SAFETY RECALL BULLETIN

June, 2016
16R1 (FL707)
NHTSA #16V-208

Subject: **Detroit Axle Sway Bar Mounting**

Figure 1 – Drilling Location For Populations A and B

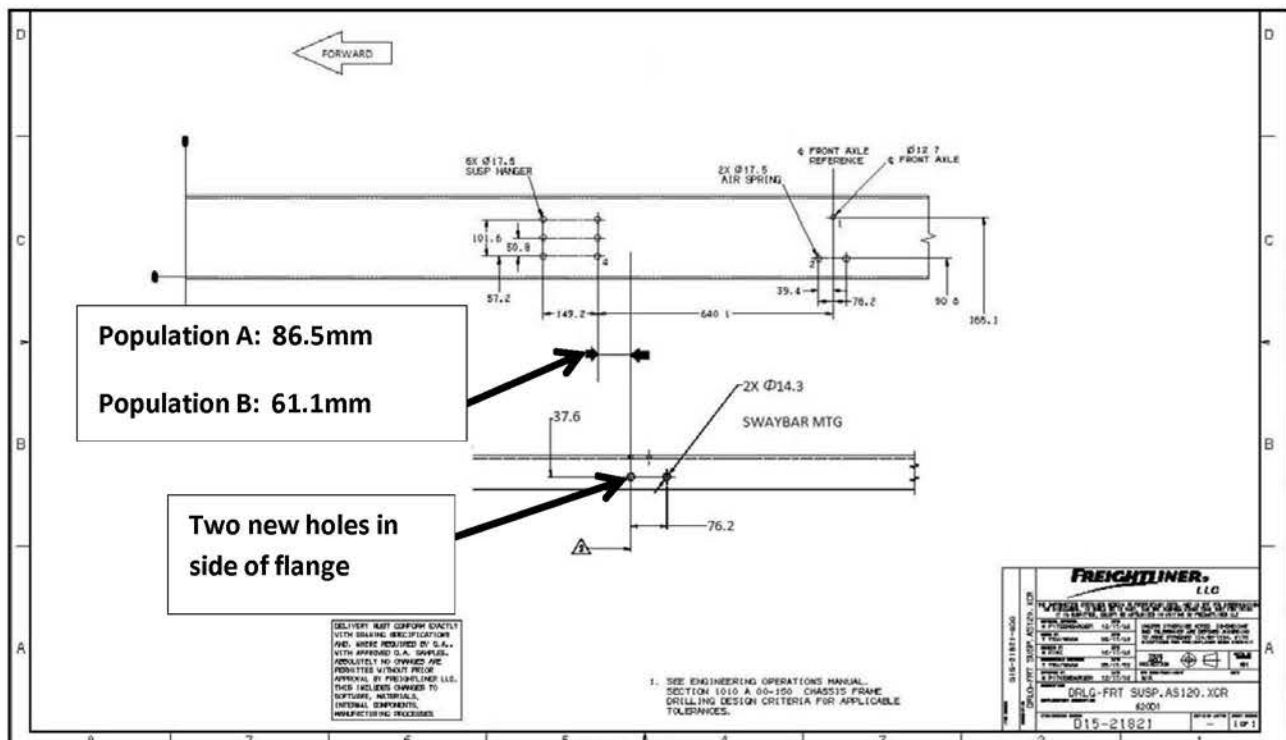
15. Remove the four axle mounting bolts and discard.
16. For vehicles in Population C, skip to step 19. For vehicles in Populations A and B, continue to the next step.
17. For vehicles in Population A or B, remove the old sway bar, stay rods, mounts, and discard.
18. For vehicles in Population A or B, drill two new holes in the frame side flange for Stay Rod Bracket P/N: 16-20587-000. Note that the dimensions are different for Population A and B. See Figure 1 below.

19. Replace with new axle mounting bolts.
20. Reinstall the spring plate.
